HORSHAM DISTRICT COUNCIL CONSULTATION

TO:	Horsham District Council – Planning Dept
LOCATION:	Mowbray Development Site, Employment Land
DESCRIPTION:	Construction of Primary Road from the Left-In, Left-Out junction with the A264 (constructed pursuant to Outline Planning Permission DC/16/1677) to Bush Lane (Bridleway 1585), footpaths and cycleways, foul and surface water drainage including a SUDS basin and foul pumping station, landscaping, substations and associated infrastructure.
REFERENCE:	DC/25/1543
RECOMMENDATION:	Objection More information
SUMMARY OF COMMENTS & RECOMMENDATION: Since the first round of comments, a River Condition Assessment has been undertaken by a qualified surveyor, with the outputs and completed watercourse module of the metric provided. It is not entirely clear on the methodology undertaken or the location of the MoRPH surveys. Additional changes made to the metric include recording of trees to be lost to the development (T273 & T356). Further information and clarification have been provided for some comments; however, some remain to be addressed, and a few new comments have arisen considering the further information provided. It is also noted that the HDC

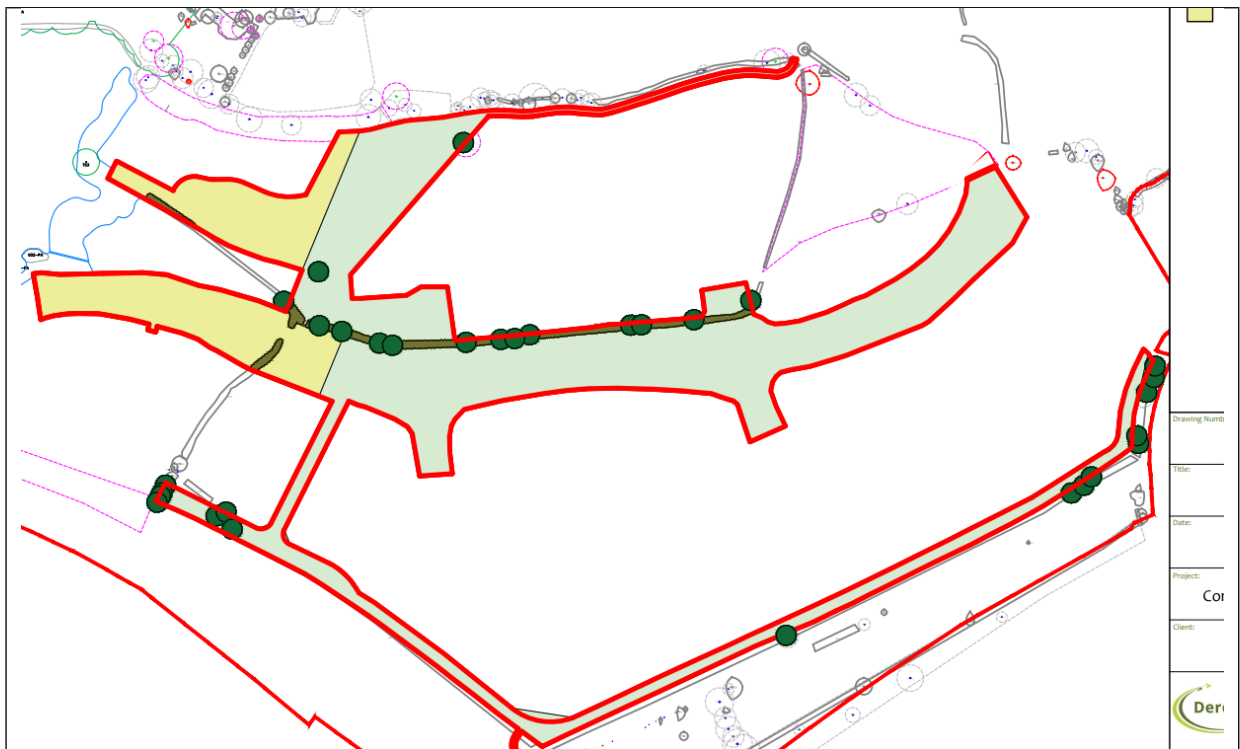
However, it should be highlighted that no methodology or location of MoRPH surveys have been provided. This is requested to determine that this has been carried out to a satisfactory level.
